Form 3160-5
(June 2019)UNITED STATES
DEPARTMENT OF THE INTERIOR
BUREAU OF LAND MANAGEMENTFORM APPROVED
OMB No. 1004-0137
Expires: October 31, 2021**SUNDRY NOTICES AND REPORTS ON WELLS**
Do not use this form for proposals to drill or to re-enter an abandoned well. Use Form 3160-3 (APD) for such proposals.

8. Well Name and No. HAWK 35 FED/508H

Hawk 35 Fed 211H (FKA 508H) API #: 30-025-47907

EOG respectfully requests an amendment to our approved APD for this well to reflect the following changes:

WELL LOCATION AND ACREAGE DEDICATION PLAT

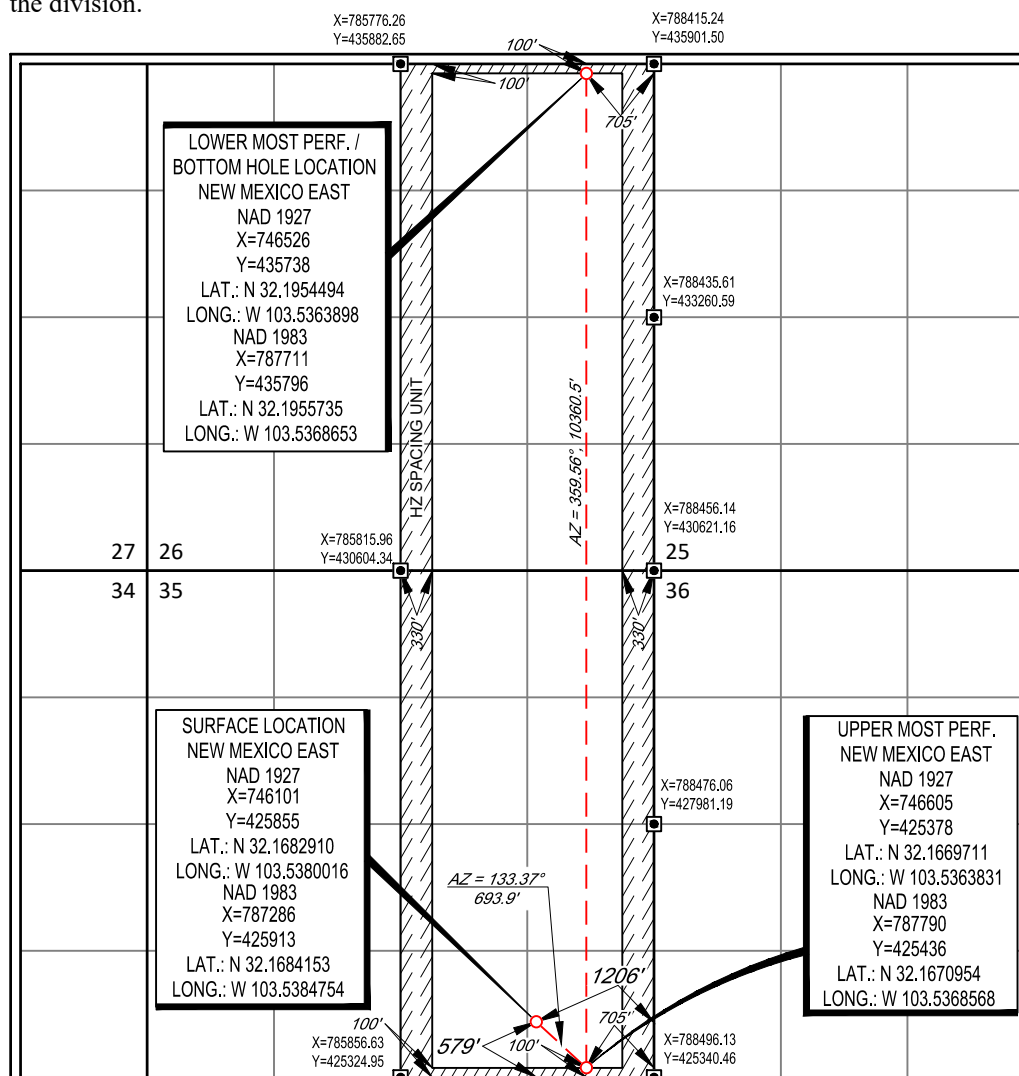
Change BHL from T-24-S, R-33-E, Sec 26, 100' FNL, 330' FEL, Lea Co., NM, to T-24-S, R-33-E, Sec 26, 100' FNL, 705' FEL, Lea Co., N.M.

UL or lot no.	Section	Township	Range	Lot Idn	Feet from the	North/South line	Feet from the	East/West line	County
A	26	24-S	33-E	—	100'	NORTH	705'	EAST	LEA

Figure 1: Cameron TA Plug and Offline Adapter Schematic

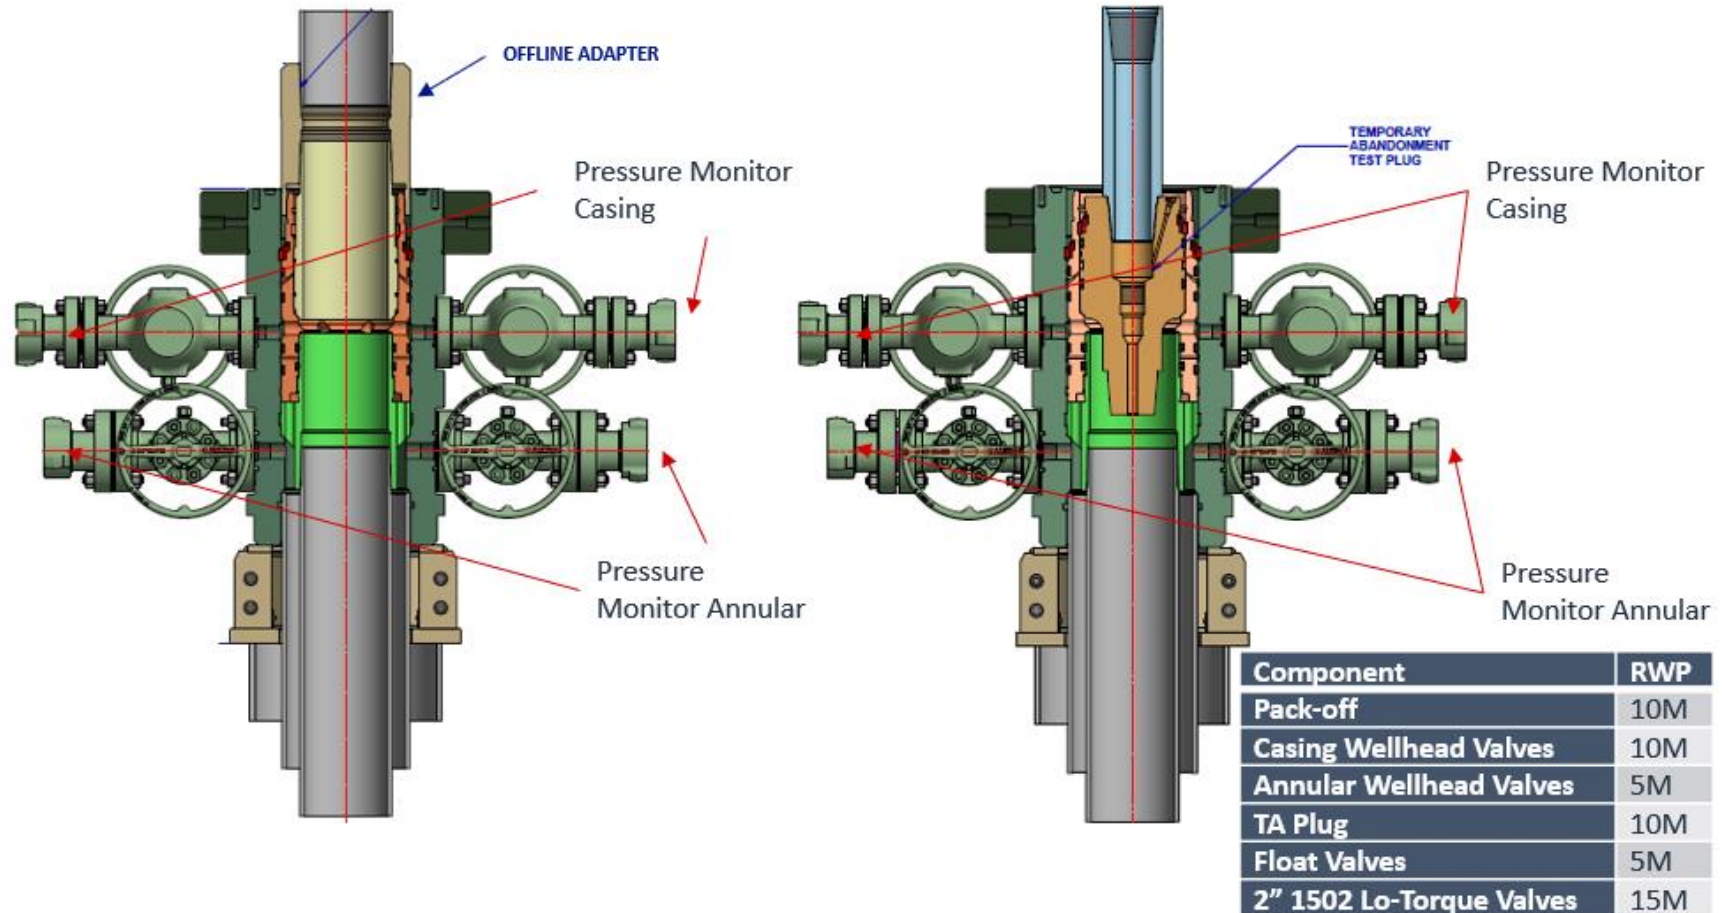
- c. Return line schematics can be seen in Figure 3.
10. Remove TA Plug from the casing.
11. Install offline cement tool.
 - a. Current offline cement tool schematics can be seen in Figure 1 (Cameron) and Figure 2 (Cactus).

Figure 4: Rig Placement Diagram

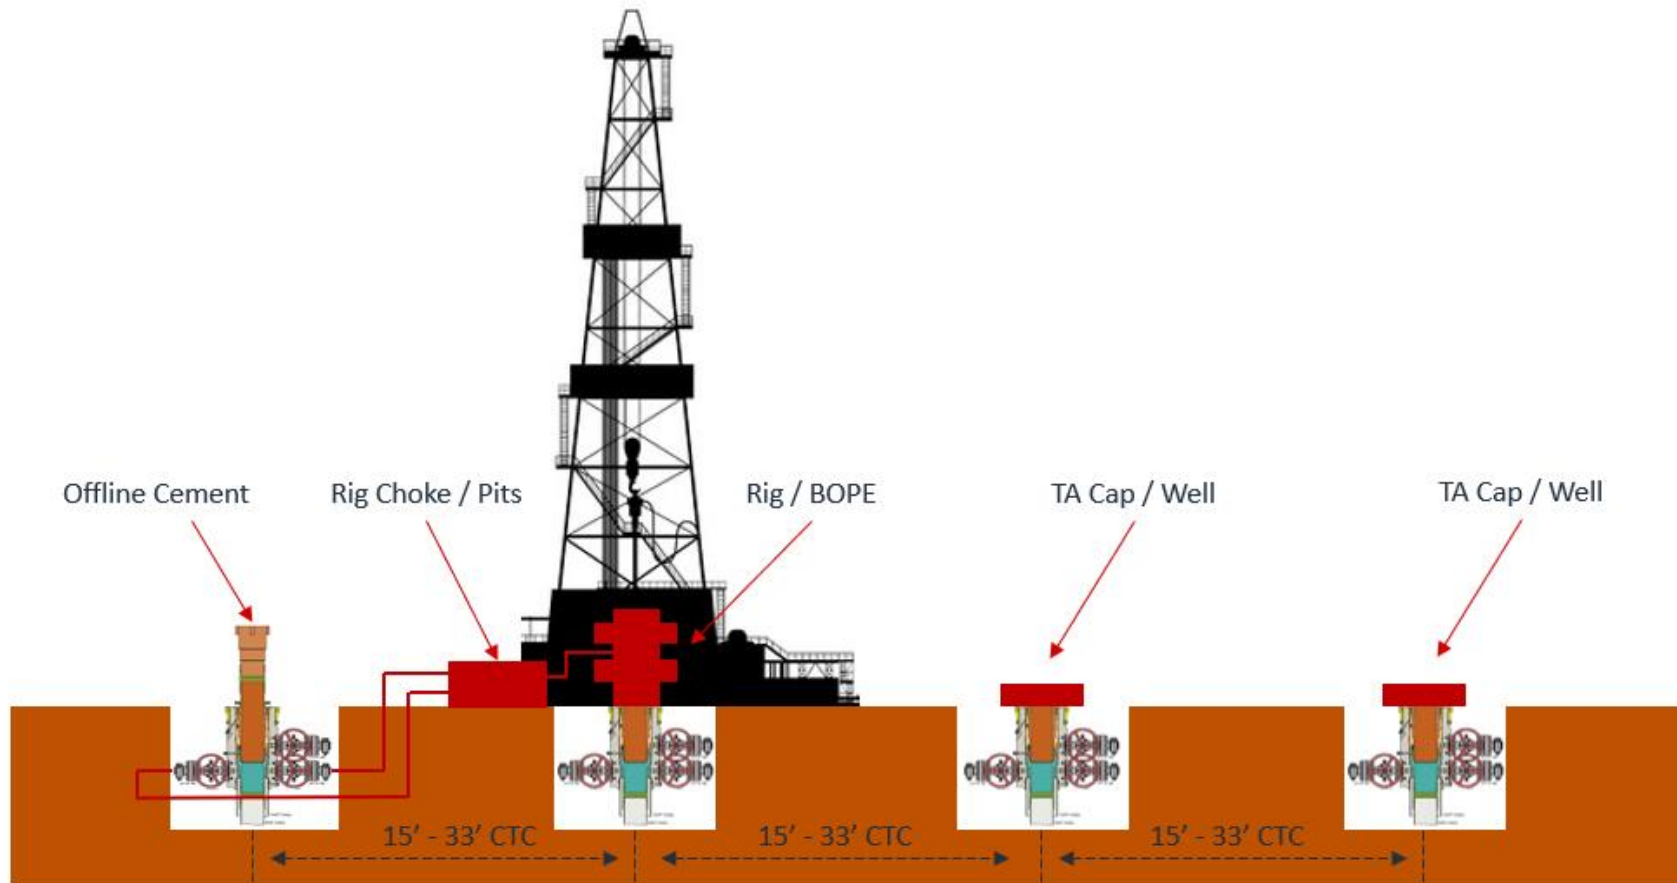
- e. Diagram for rig positioning relative to offline cementing can be seen in Figure 4.
9. Rig up return lines to take returns from wellhead to pits and rig choke.
